TECHNICAL INFORMATION COMMUNICATION

Number: TIC2014-0001

Title: New Trap Heater Kit

Product Category: Gas Furnaces

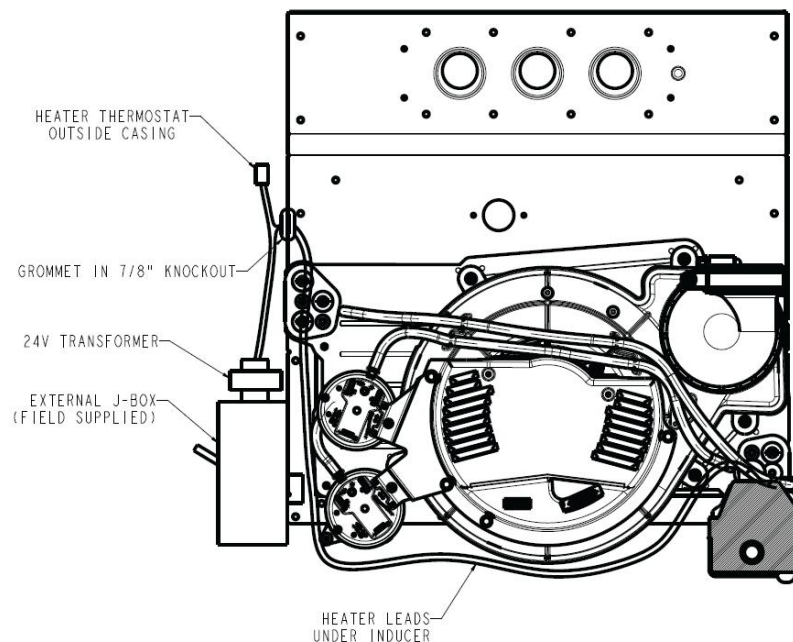
Effective January 1, 2014, the condensing gas furnace trap heater kit, KGAHT0201CFP, is now available for shipment to all distributors. The condensate freeze protection (condensate trap with heat pad) kit is designed to protect a high-efficiency furnace condensate drain trap from freezing when the furnace is installed in an area where temperatures may be below 32F (0C).

The trap heater kit includes a completely new trap with the heating pad affixed to it to prevent freezing of condensate in the trap. The kit also includes a step-down transformer that provides the 24V required for the heating pad, and an in-line thermostat to turn on the heating pad when ambient temperatures reach 35 degrees.
